**ADDENDA
00 91 13 E-03**

Project:
COMMUNITY CARE CITY OF KAWARTHA LAKES CCCKL COMMUNITY HEALTH CENTRE

Drawing Title:
GROUND FLOOR PLAN - POWER AND SYSTEMS

Scale: 1 : 75
Date: 2021/07/05
Job No.: 2171348
Drawn by: JP
Drawing No.: **E300**

1.1 Refer to Drawing E300 – Ground Floor Plan – Power & Systems (issued within)

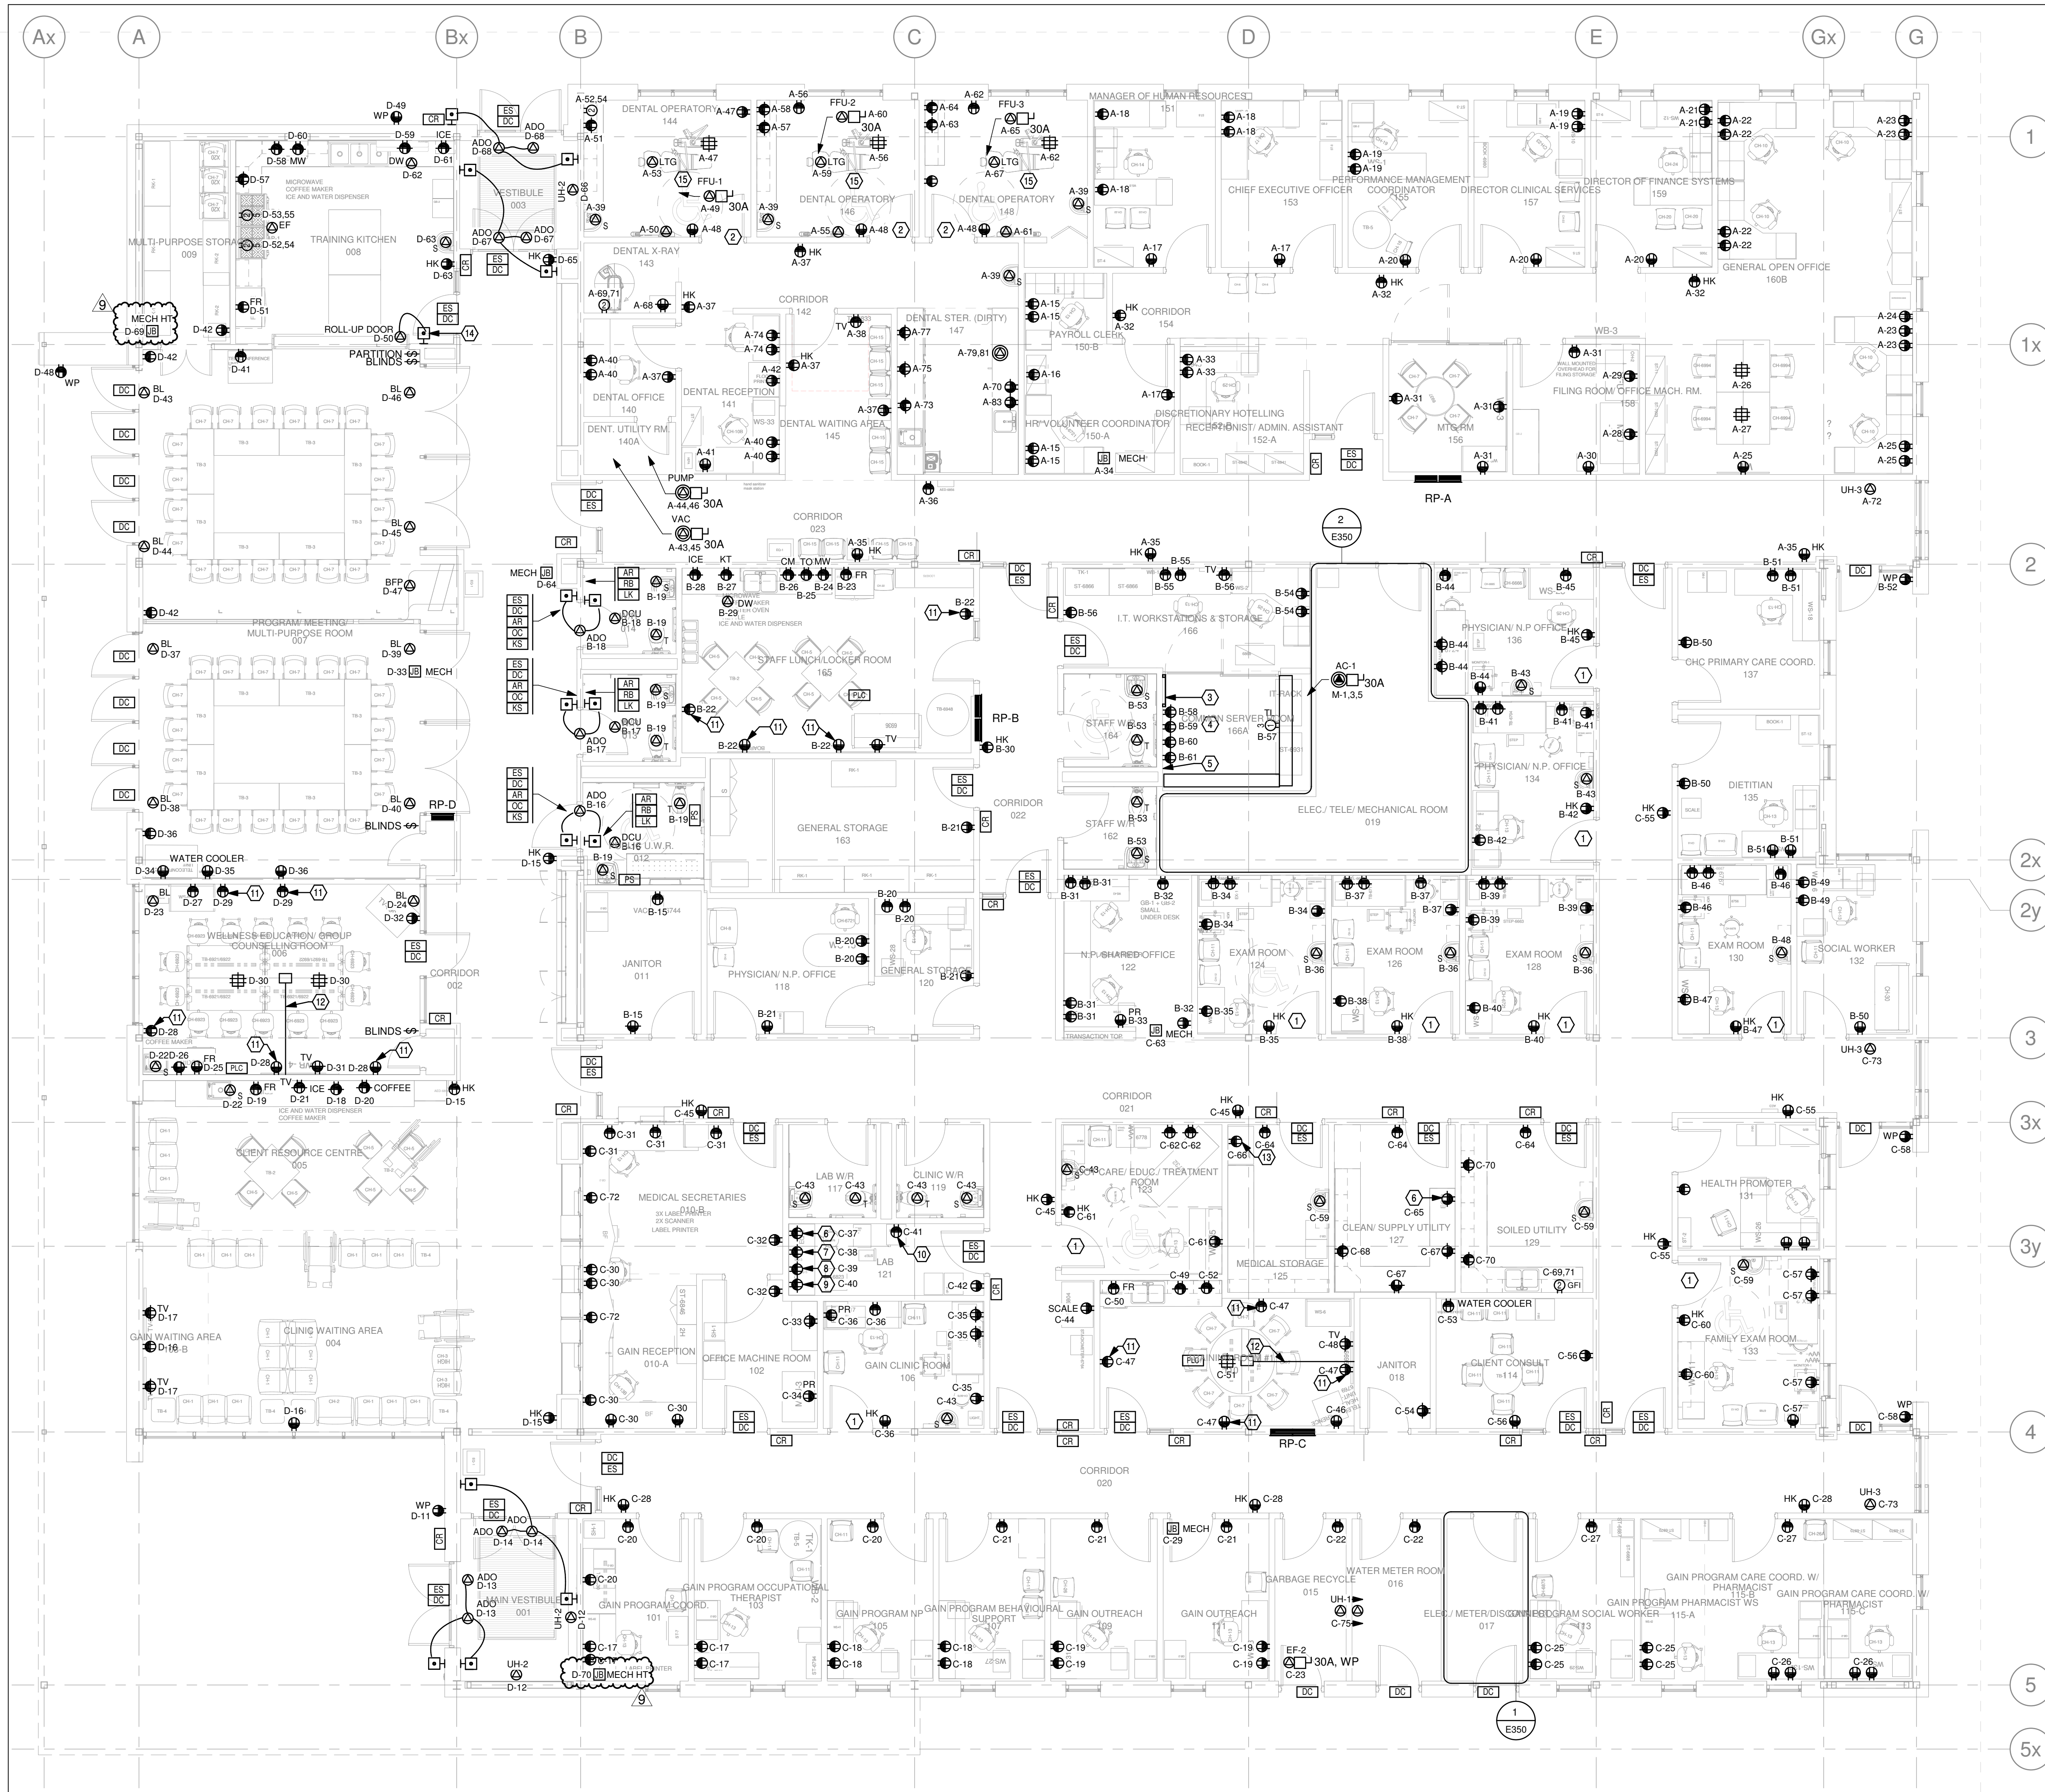
- .1 Added two 120V GFI circuits to be used for heat tracing. Power is by division 26, heat tracing cables, controller etc are by division 20.
